PLANNING COMMISSION STAFF REPORT

AGENDA ITEM: Planning File No. MODSP-25-0003: A modification to MAJ-23-0011 to

LOCATION: 101 W Main ST / Lot B-1 West Frisco 70 SUB # 2

MODSP-25-0003

3. Architectural Roof Plan (Sheet A2.4)

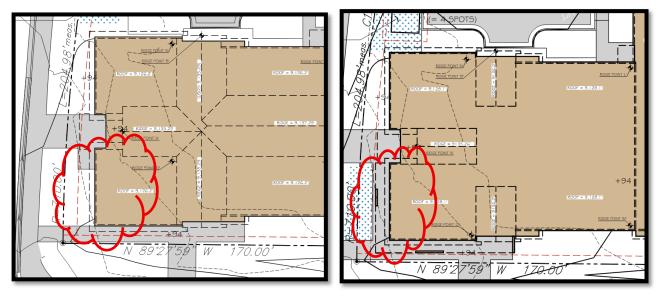
• Elevation updates include adjustments to the top of plywood and ridge elevations to reflect changes in slab and floor-to-floor heights. Additionally, the roof configuration has been modified, replacing the central pitched roofs with flat roofs and a mechanical screen to align with the mechanical requirements identified at 602 Galena Street.

Sheet A2.1

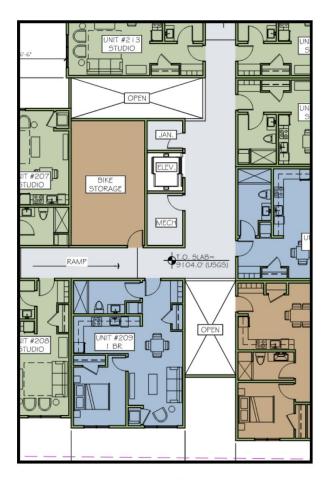
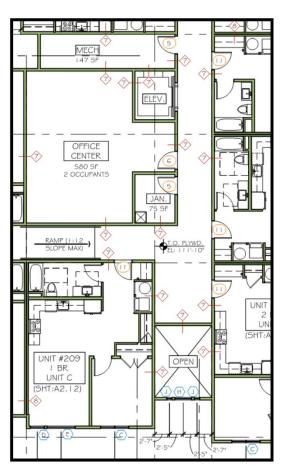
The proposed modifications do not include a change to the number of bedrooms or entry points. The bike storage-has been reconfigured but still meets compliance with Town Code by providing 26 bicycle parking spaces inside of the 52 spaces required, the elevator was moved, the janitor's closet was moved and expanded, a mail room, office center, and to lounge were added, and the mechanical rooms were reconfigured.

The structure continues to be in compliance with bike storage requirements, and no modifications are proposed to the unit count or number of bedrooms.

Architectural Roof Plan (Sheet A2.4)

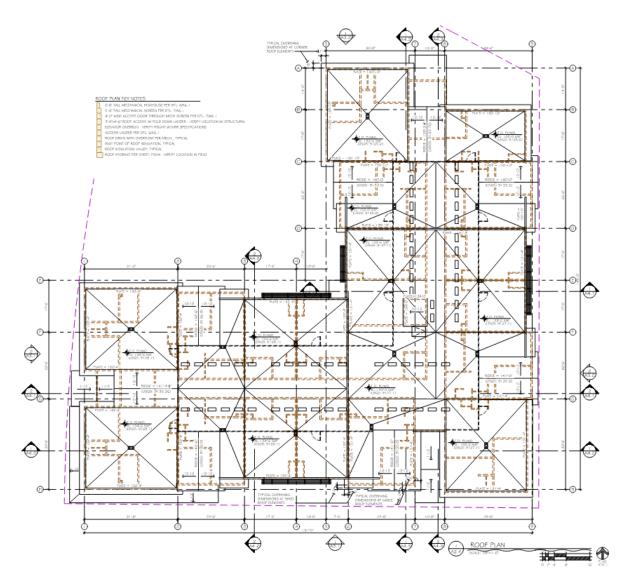
Staff has reviewed the proposed modifications to the roof design, which include two main modifications. The first change involves adjusting the top of the plywood and ridge elevations to ensure consistency with revised slab and floor-to-floor heights. This is considered a minor correction. The second, more significant change is replacing the pitched roof with a flat roof due to mechanical system requirements. A mechanical screen will be added to hide rooftop equipment, in line with Code requirements. Staff has verified that the new roofline and screening comply with the maximum height limits for this zone. Please see page A2.4 in the Application to see a full detail of the roof plan.

The structure continues to be in compliance with all height, bulk plane, and roof standard requirements with these proposed modifications.
